First Level Appeal
Atascadero City Hall

City of Atascadero

**SUBJECT: Atascadero City Hall
First Level Appeal, PW 229-1
FEMA-1505-DR-CA, P.A. ID 079-03064-00
City of Atascadero**

Figure XIII. Upper rotunda crack mapping.

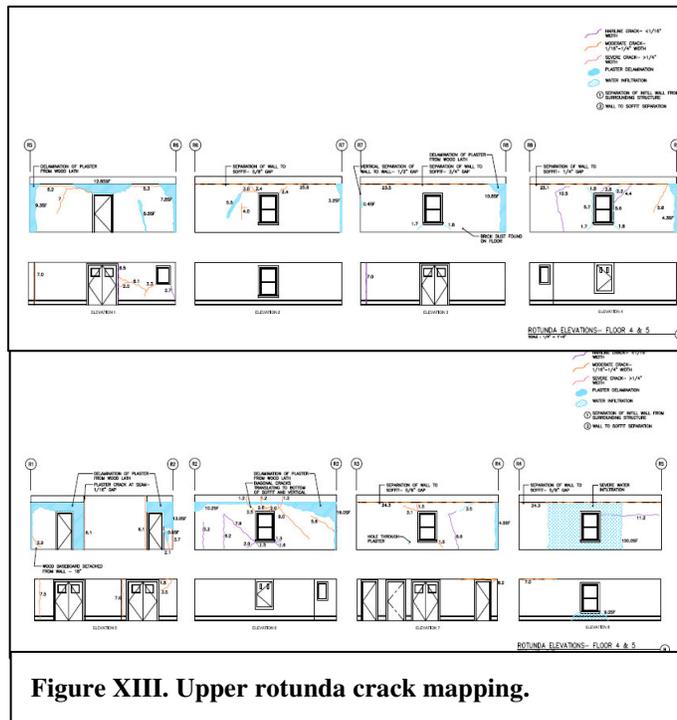
- In Volume III of the City's Damage Assessment, Sheets A255 & A256, the room is broken down into 8 manageable segments of wall. (Figure XIII)¹²⁴ In almost every segment of the wall, there are varying level of documented cracks.
- FEMA regulations clearly state that funding will be provided to return a building to its pre-disaster condition. In the case of Atascadero City Hall, that condition included the fact that the wall in the upper rotunda was uniformly painted. The unpainted section of the wall would still not be consistent with the other freshly painted areas of the walls in the room, and the facility would not be returned to its pre-disaster condition.
